**Revised Phase B Site Investigation
Work Plan
Text, Tables, and Figures**

**Tronox LLC Facility
Henderson, Nevada**

AECOM, Inc.
December 2008
Document No.: 04020-023-430

Subject: Revised SAP Tables, Figures and Plates for the Phase B Source Area Investigation Work Plans for Areas I, II, III and IV, Tronox LLC Facility, Henderson, Nevada (Facility # H-000539)

For: LOU 35 (2 changes)
 + 0 = add 1 boring

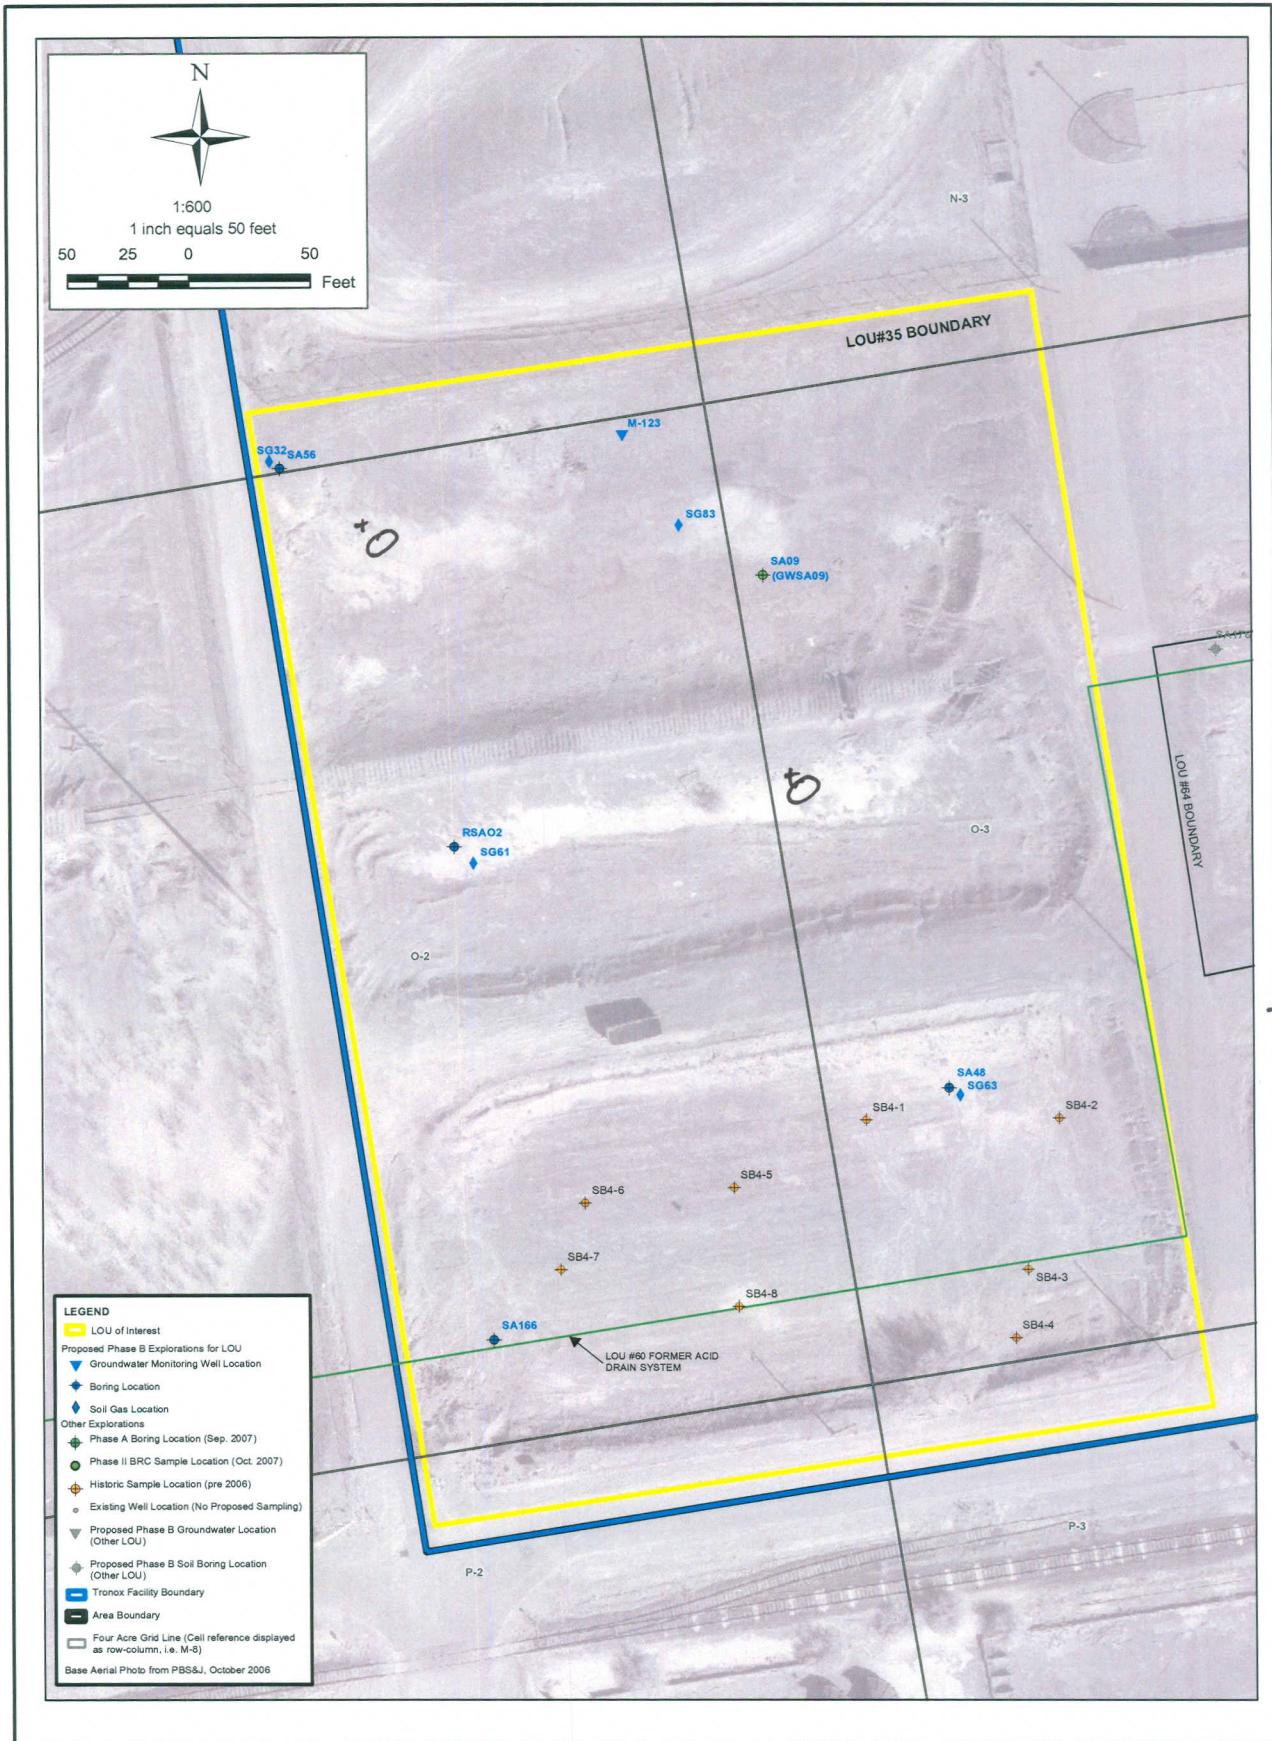
- i. Table A, please see the above comments for Table 2 as applicable.
 - ii. Figure 1, the NDEP has the following comments:
 - 1. An additional boring should be added in the large white-stained area near the northwest corner of LOU 35.

For: LOU 64 (3 area I changes)
 O = relocate boring to location

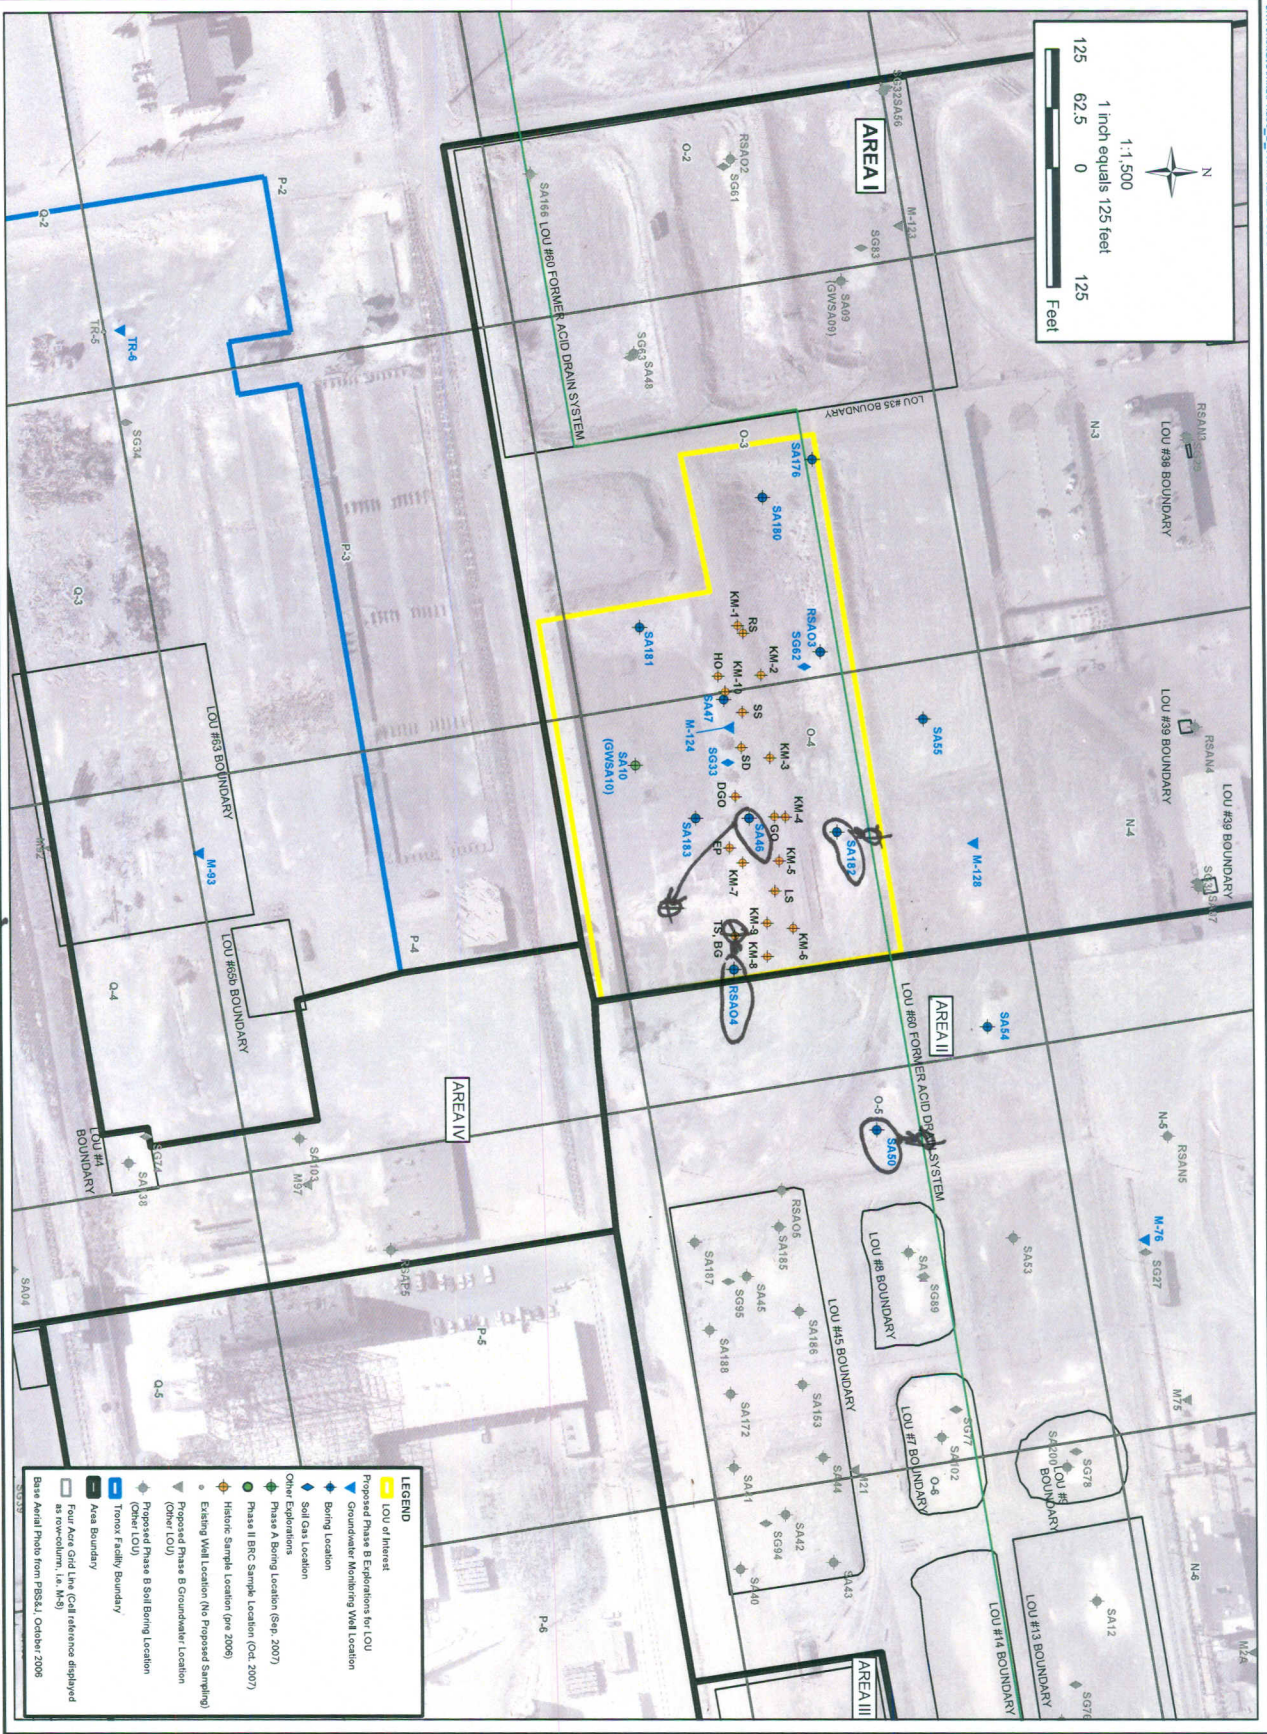
- ii. Figure 1, the NDEP has the following comments:
 1. SA46 should be relocated approximately 75 ft west of the eastern boundary and 90 ft north of the southern boundary of LOU 64.

For LOU 60 (4 Area I changes

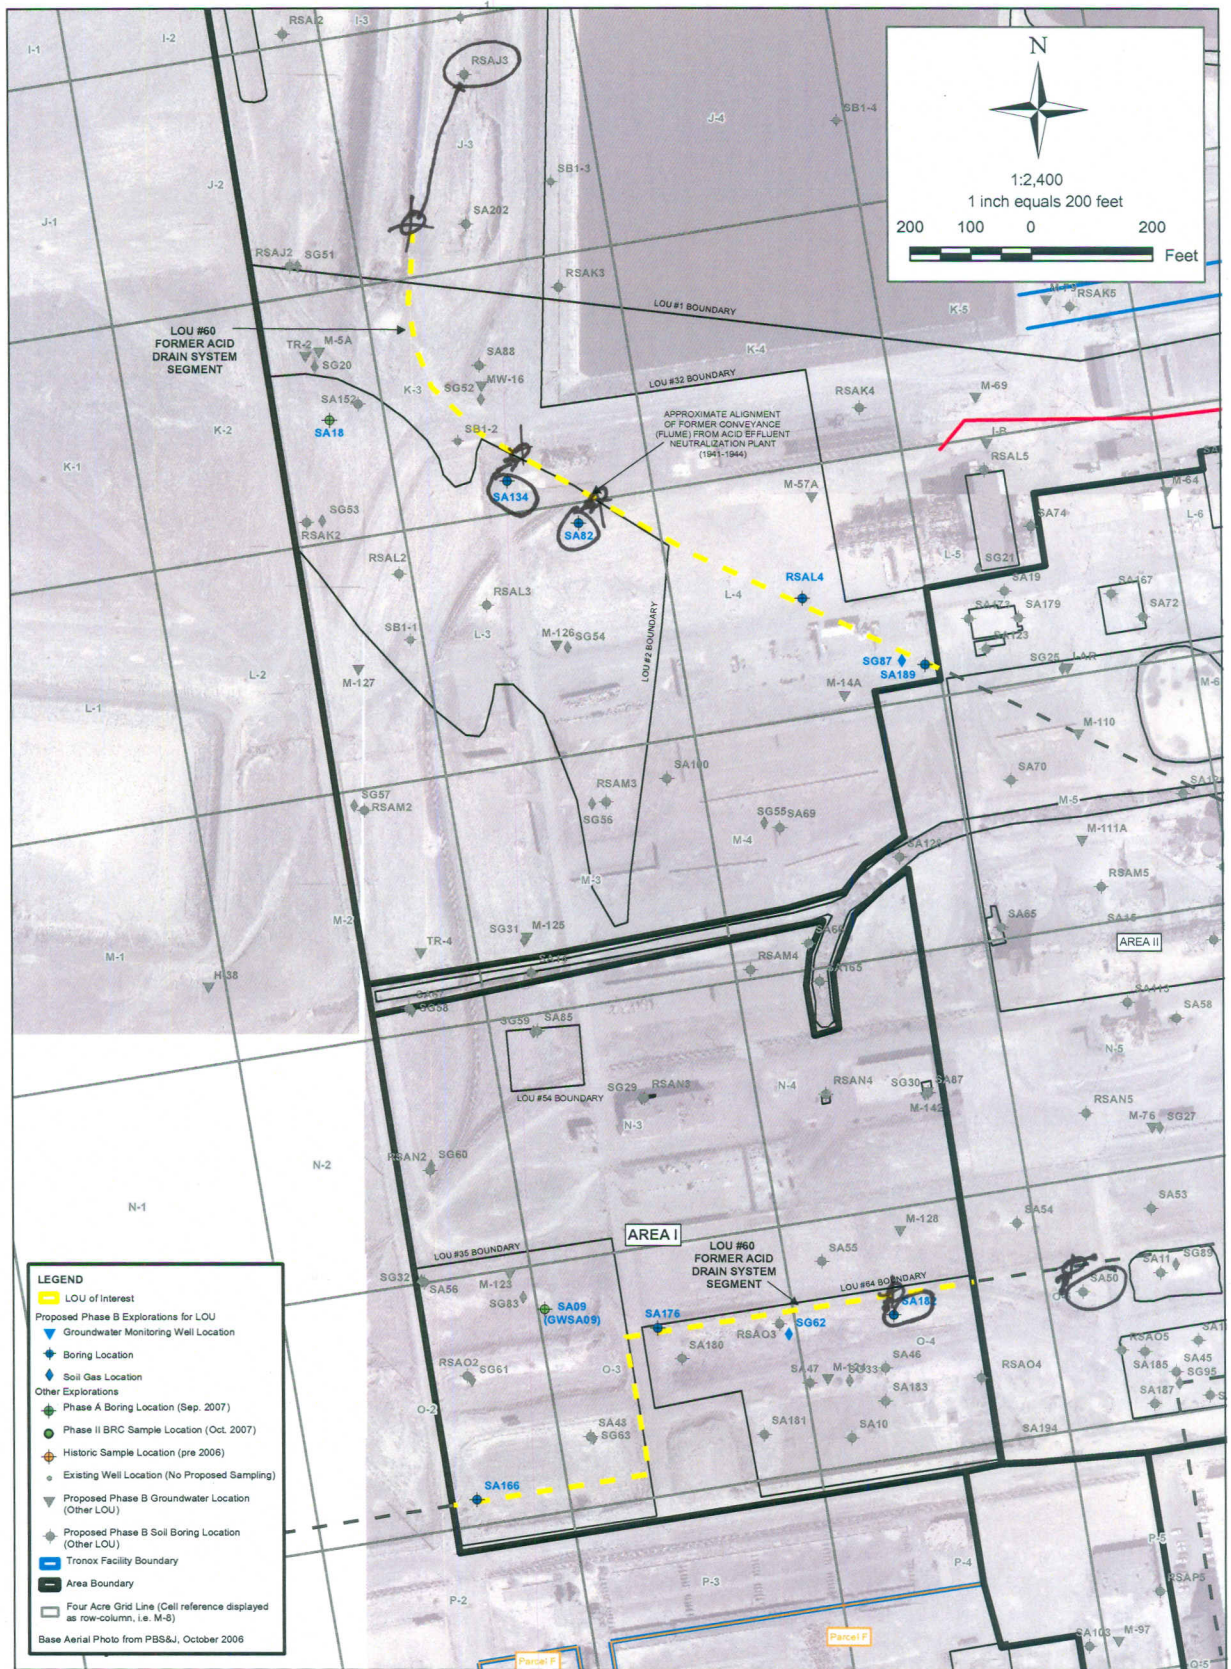
- ii. Table B, please see the above comments for Table 3 as applicable.
 - iii. Figure 1, the NDEP has the following comments:
 - 1. General comment, LOU 60 should be noted.

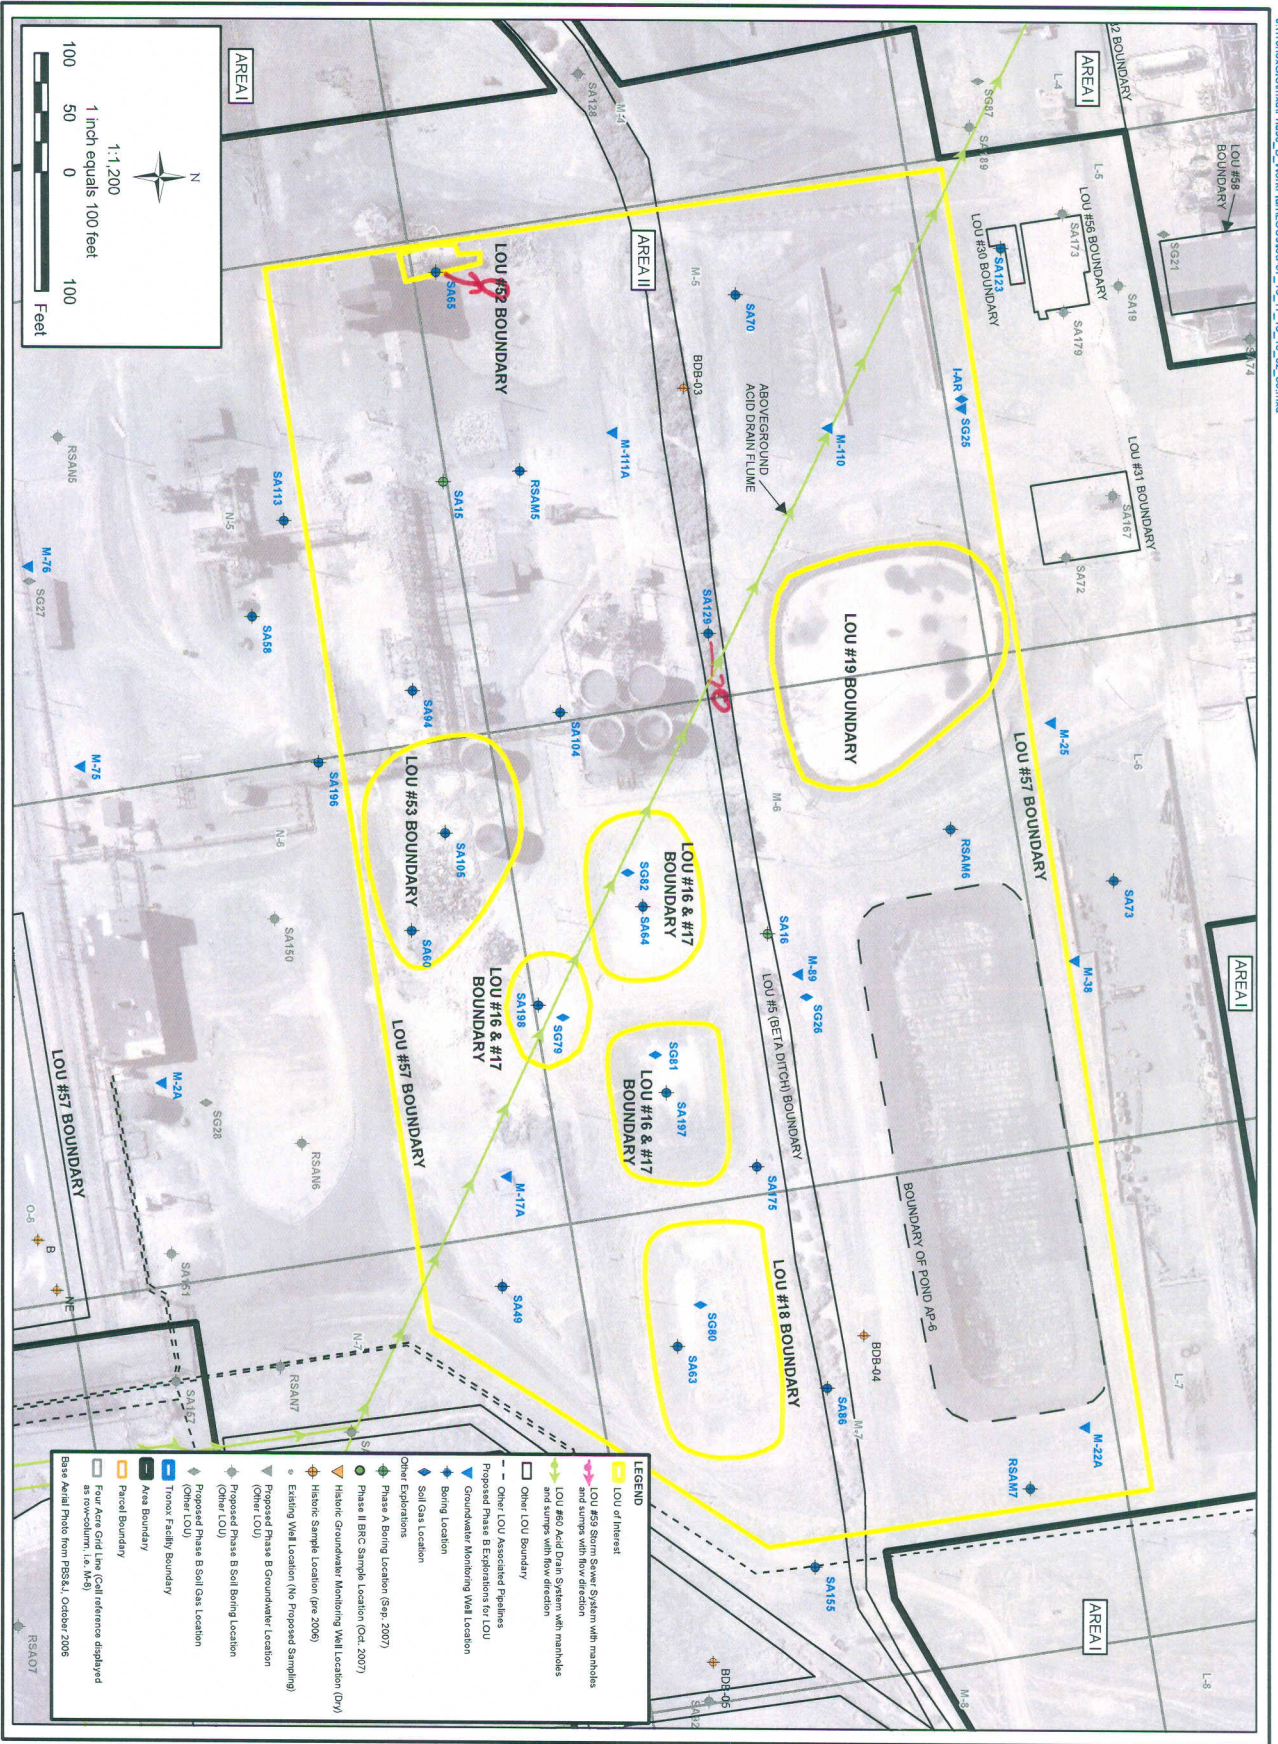
move S465 to area of depression off of NECC of LOU #52

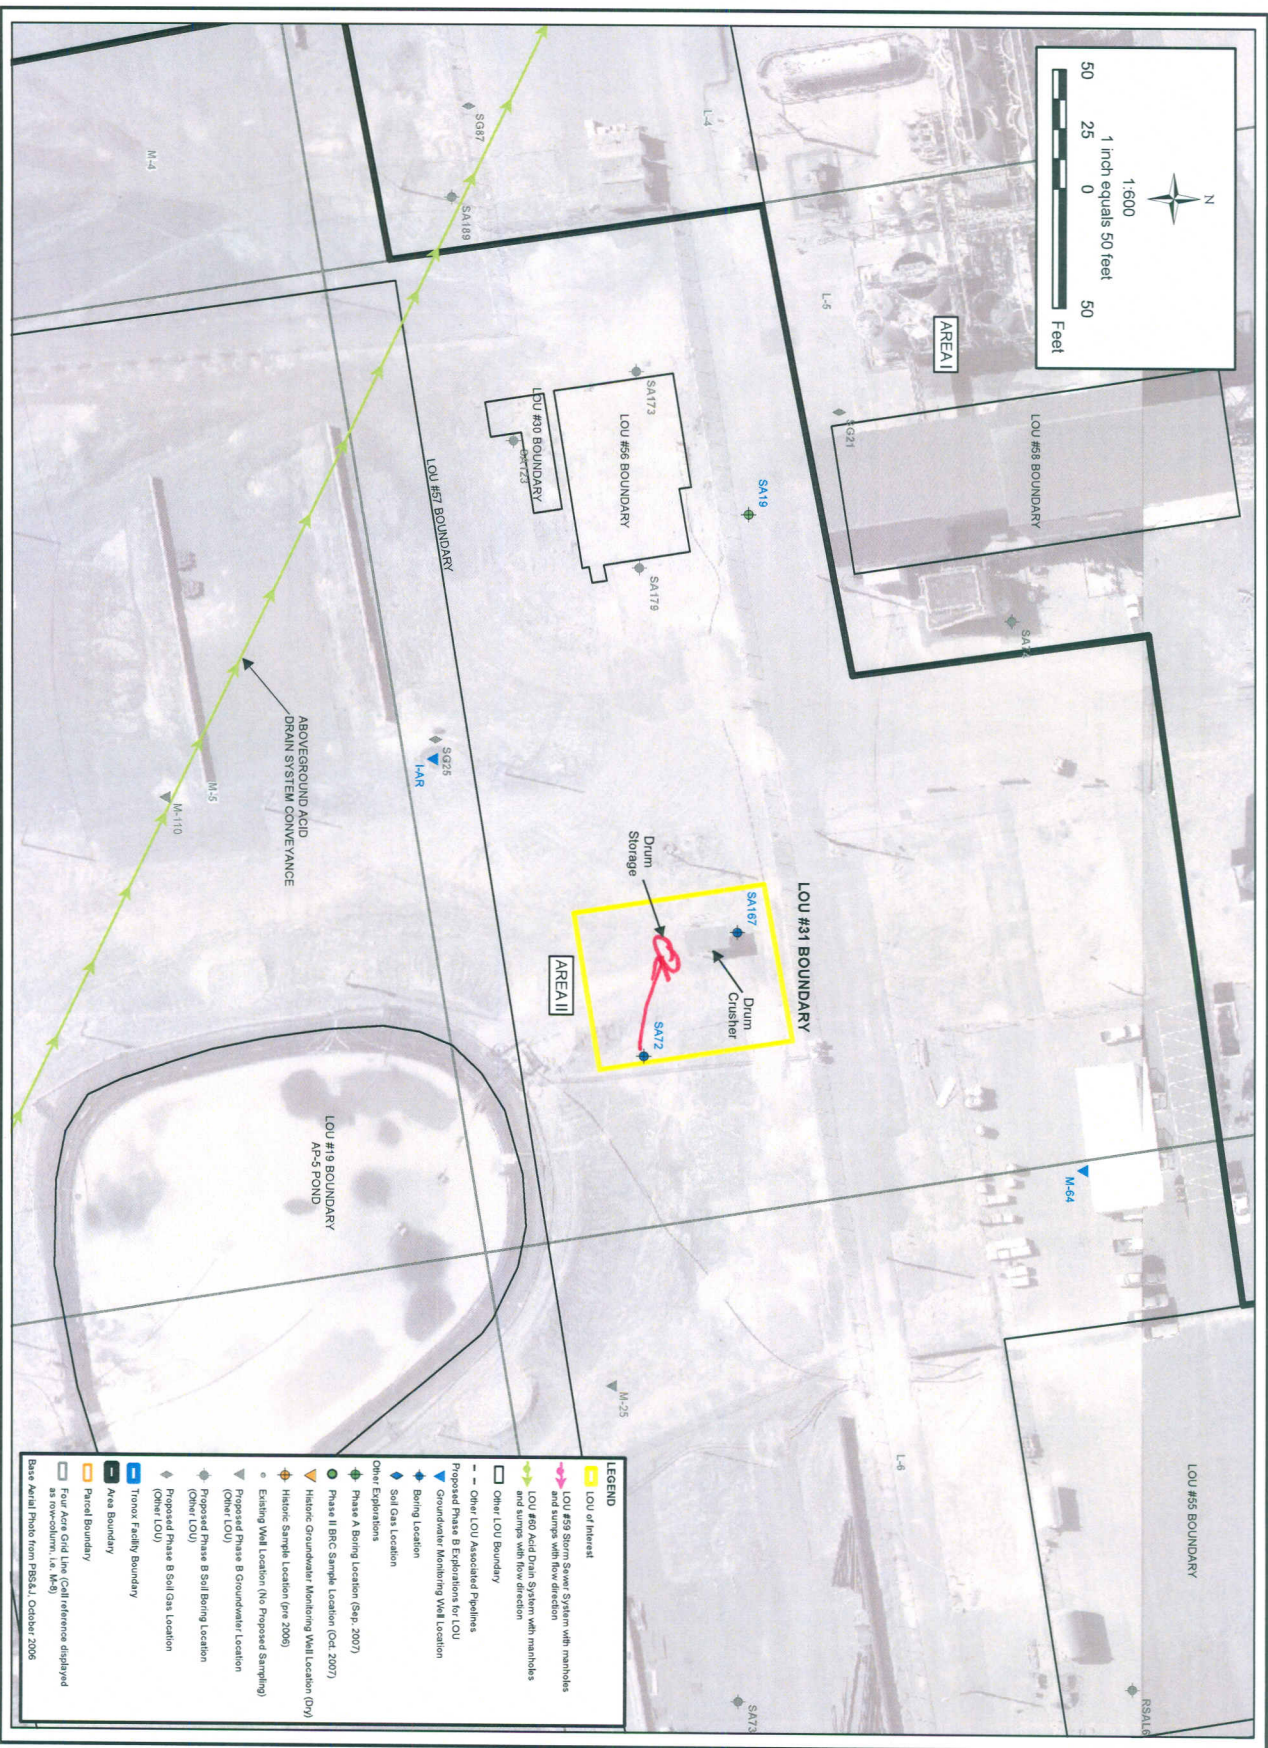
Move SA72 to Drum Storage Area
